From: [REDACTED]
To: [REDACTED] [Sandy Vossler](#)
Subject: Master plan - proposed changes to filing 16 parcel 6
Date: Sunday, January 2, 2022 2:19:09 PM

From: [R.C. Hanisch](#)
To: [Adam Brink](#); [Sandy Vossler](#)
Subject: RE: Proposed Site Development Plan Amendment for a portion of Meadows Filing 16, Parcel 6
Date: Thursday, March 24, 2022 11:51:07 AM
Attachments: [The Meadows Filing 16, Parcel 6 Meeting 1 - Presentation.pdf](#)

Link and screenshot of traffic count is below...

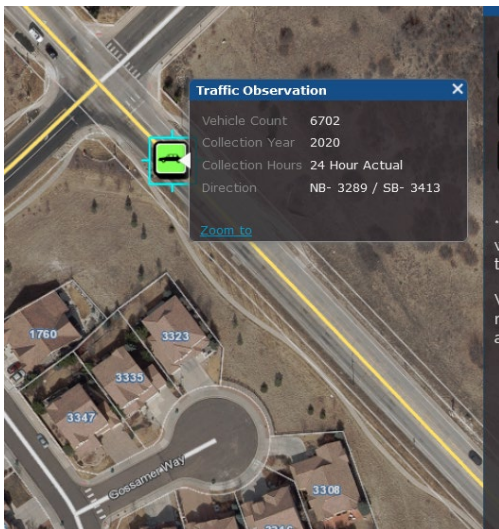
I spoke up in the neighborhood meeting on Monday 1/10 with concerns about traffic on Coachline (in particular between Wolfensburger and Foothills). I cited that according to the interactive CR traffic count map there were 6702 vehicles recorded in 2020 over 24 hours. This could be delivery vehicles, people going to and from work, people crossing from one road to another, using the open space, etc. My guess is that number has grown.

In the new neighborhood at Coachline and Wolfensburger there are two Coachline-facing neighborhood entrances. The proposed neighborhood for filing 16, parcel 6 will add two more entrances. In the case of the proposed neighborhood those two entrances are the only way in and out.

I'm not sure when a road is considered over-burdened with traffic but the way these neighborhoods are being designed with inlets/outlets onto Coachline, traffic will only get heavier. I already notice a difference when I try to pull out of Freedom onto Coachline. The speed limit is 40 mph but there are plenty of vehicles that challenge that on a daily basis.

So, with the increase in volume on an already heavily used road I would think this presents some safety issues for bicyclists, pedestrians and residents entering and exiting neighborhoods along Coachline including the new neighborhoods.

What steps can be taken to mitigate traffic to increase the level of safety for all? More roundabouts? Lower speed limits? Speed bumps? Traffic lights? Please consider my concerns and review possible solutions to throttle traffic in a more effective, safer way before it gets worse.
